# Access Compliance Report

## Public Rights-of-Way

Intersection ID: 8157	Main Street: N_TRYON_ST	Cross Street: ORR_RD	Location: SE
ADA ID: 044FB9957631	Ramp Type: Perp	Initial Pass/Fail: Fail	Overall Compliance: No
Severity Score: 8.75			
Codes/Mitigation Info/Possible Solution		Field Measurements/Component Compliance

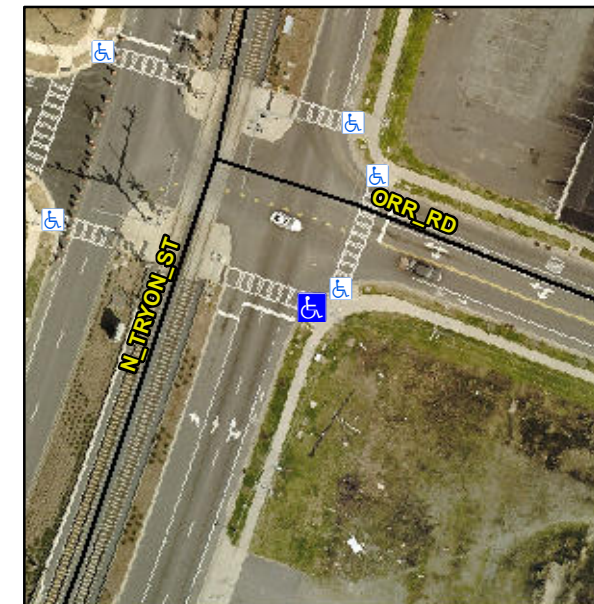
**Not Found, R304.5.1**

Compliance	Description	Data	Compliance	Description	Data
N/A	Ramp Length (in)	99.0	Yes	Ramp Slope (%)	6.4
No	Ramp Width (in)	47.0	Yes	Ramp XSlope (%)	1.4
N/A	Flare Type LT	N/A	N/A	Flare Type RT	N/A
N/A	Flare Slope LT (%)	N/A	N/A	Flare Slope RT (%)	N/A
N/A	Flare Traversable LT?	N/A	N/A	Flare Traversable RT?	N/A
N/A	Landing Length (in)	N/A	N/A	DWS Provided?	N/A
N/A	Landing Width (in)	N/A	N/A	DWS Contrast?	N/A
N/A	Landing Slope (%)	N/A	N/A	DWS Length (in)	N/A
N/A	Landing X Slope (%)	N/A	N/A	DWS Full Width?	N/A
N/A	Landing Curb? (Y/N)	N/A	N/A	DWS Offset (in)	N/A
N/A	Shared Landing?	N/A			
N/A	Gutter Ponding?	N/A	N/A	Gutter Slope (%)	N/A
N/A	Gutter Lip Ht (in)	N/A	N/A	Gutter X Slope (%)	N/A
N/A	Painted X Walk1?	Yes	N/A	Painted X Walk2?	N/A
	X Walk 1 Direction	To W		X Walk 2 Direction	N/A
N/A	X Walk 1 Width (in)	104.0	N/A	X Walk 2 Width (in)	N/A
	X Walk 1 Slope (%)	4.2		X Walk 2 Slope (%)	N/A
	X Walk 1 X Slope (%)	0.5		X Walk 2 X Slope (%)	N/A

**Remove & Replace Entire Ramp.**
